August 2, 2017

RE: Change Order Request No. 5 for the Block System Cleaners Facility Located at 2017 Winnebago Street in Madison, Wisconsin – BRRTS No. 02-13-552132; ReadyEarth Project no. 11-0604

The DNR committee recently provided comments (attached) to our *Technical Assistance Work Plan* dated June 29, 2017. ReadyEarth incorporated those comments into a revised scope of work and prepared this change order request. The scope includes conducting a shallow soil investigation (i.e. above the water table) within the anticipated source area; installing three new off-site piezometers and a new off-site water table observation well; conducting four rounds of quarterly groundwater sampling; conducting paired sub-slab and indoor air sampling within the 2000 Atwood building; and documenting the activities in a SI report addendum. The report will include our conclusions and recommendations for the subsequent phase of work for the site, which may include a closure request. ReadyEarth has documented the estimated costs for the additional work on the attached DNR linking spreadsheet. The following sections describe the work in detail.

**B.1.b Detailed Site Map**  
 Block System Cleaners  
 2017 Winnebago Street  
 Madison, Wisconsin

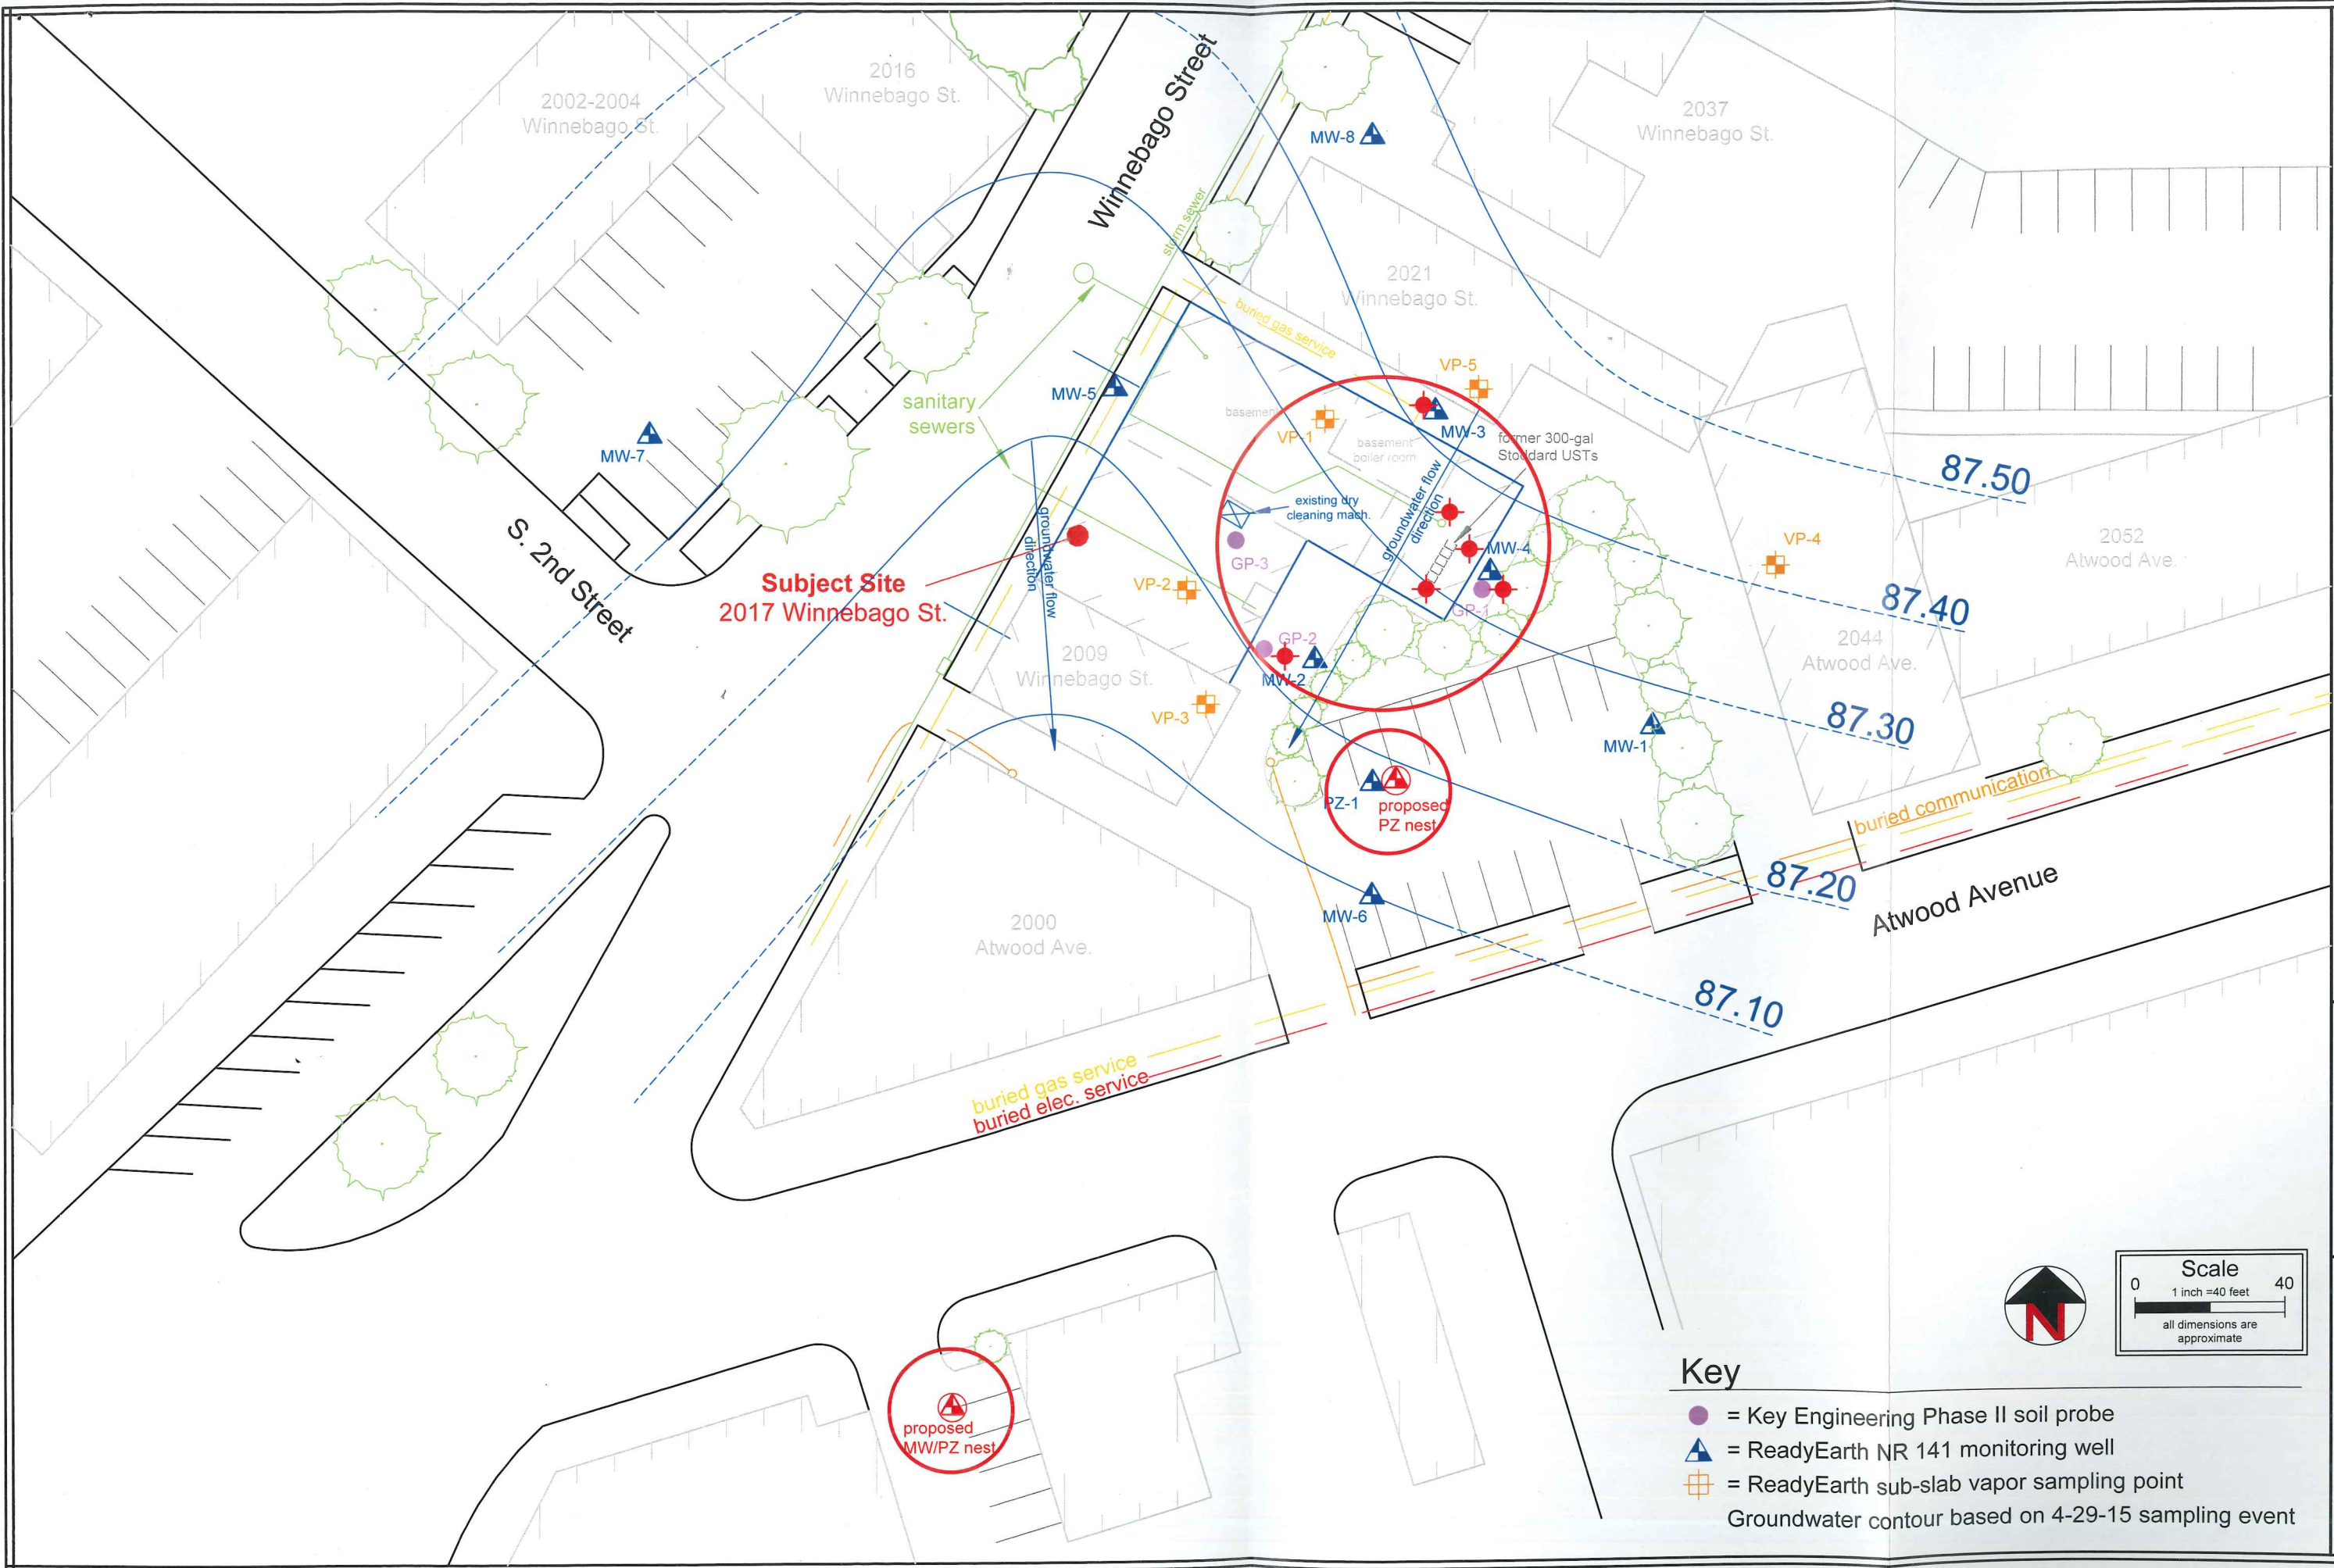
ReadyEarth will document the procedures utilized by a soil probe contractor to advance a soil probe at approximately six locations: three locations within the building footprint in the vicinity of the former Stoddard underground storage tanks (USTs); and three exterior locations adjacent to the previous sampling locations GP-1, GP-2, and MW-3. The probeholes will be advanced with typical direct push technologies. Each probehole will be advanced to approximately 12 feet below ground surface (bgs) and will likely terminate above the water table. The purpose of the probeholes is to conduct a vadose zone source evaluation and evaluate the presence/composition of fill, if any. The anticipated locations for the proposed probeholes are illustrated on the attached figure B.1.b.

The new wells will be constructed in accordance with ch. NR 141 Wis. Adm. Code. The piezometers will include 3-foot screened sections and the water table observation well will include a 10-foot screened section. The anticipated locations of the proposed wells are illustrated on the attached figures B.1.b and B.3.a.

**B.3.a Geologic Cross-Section Figure A-A'**

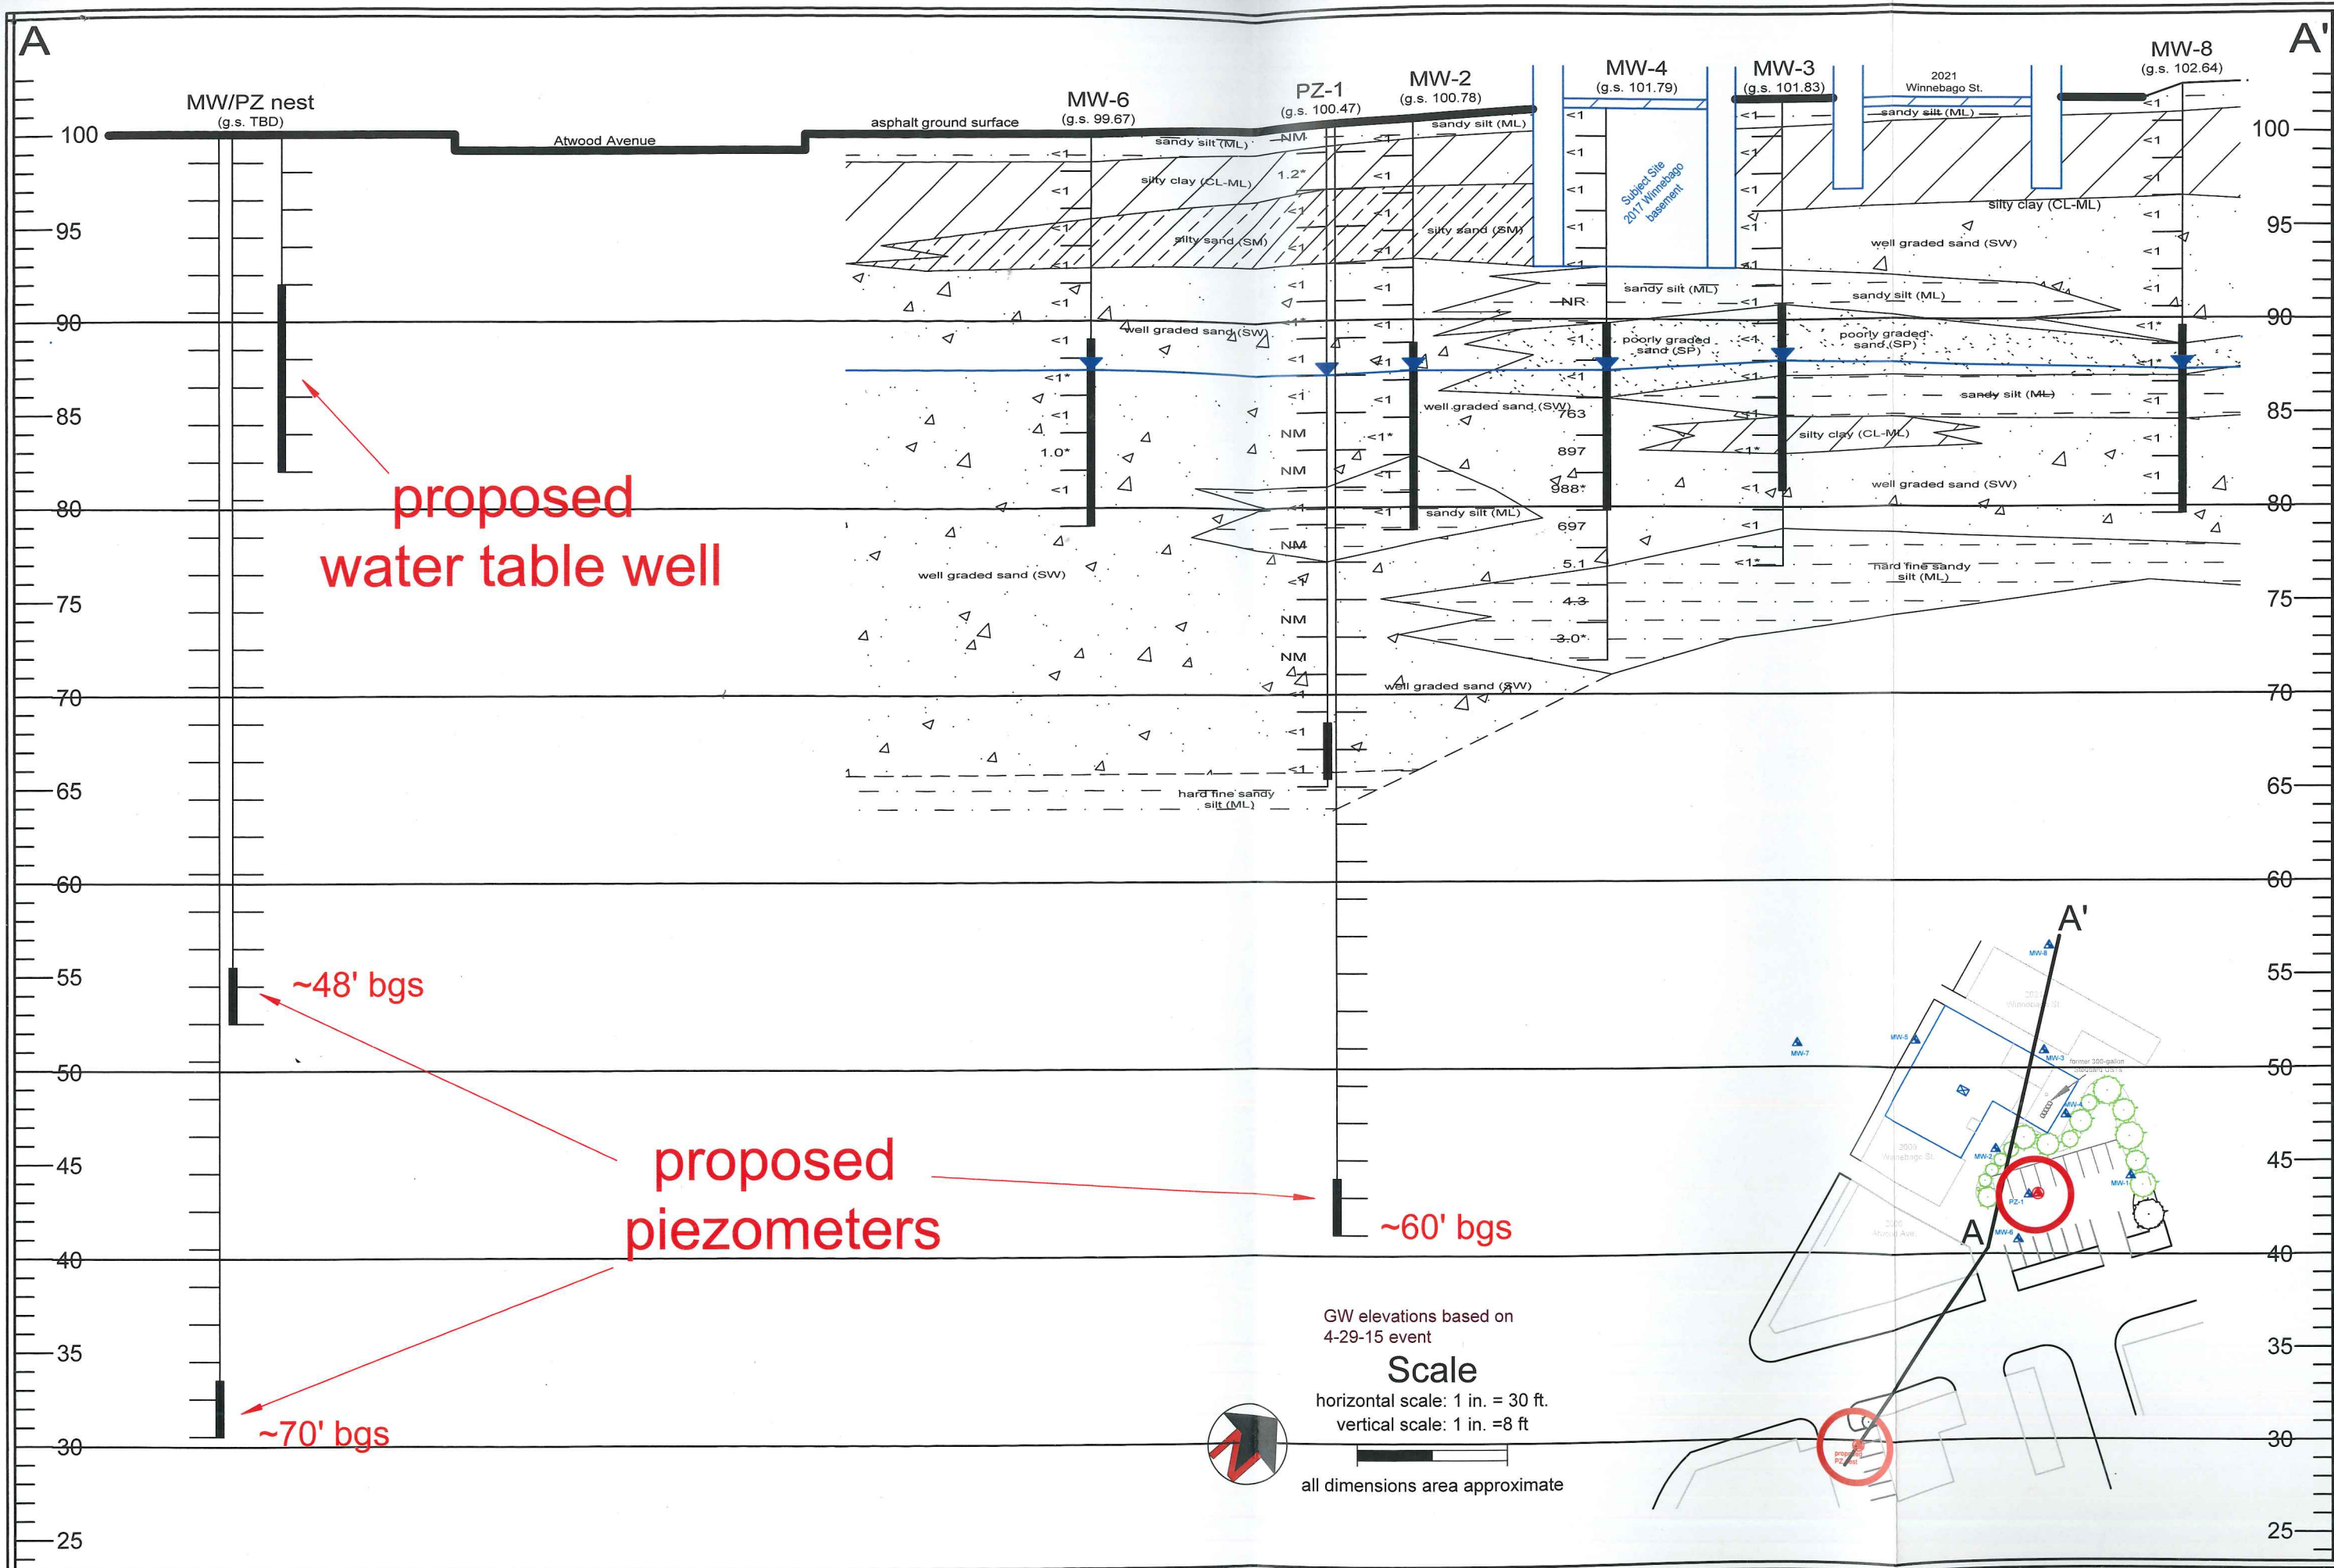
One new piezometer will be nested with the existing PZ-1 and will be screened at a terminal depth of approximately 60 feet bgs. Two additional piezometers will be nested

and installed along the downgradient flow line on an off-site property beyond Atwood Avenue. One of those piezometers will be screened at a terminal depth of approximately 48 feet bgs to evaluate the impacts detected at PZ-1. The second of those piezometers is proposed to be screened at a terminal depth of approximately 70 feet bgs to evaluate the downgradient vertical extent.

An additional water table observation well will be nested with the new piezometers across Atwood Avenue. The well will be installed at a terminal depth of approximately 18 feet bgs and will be constructed so that the screen intersects the water table
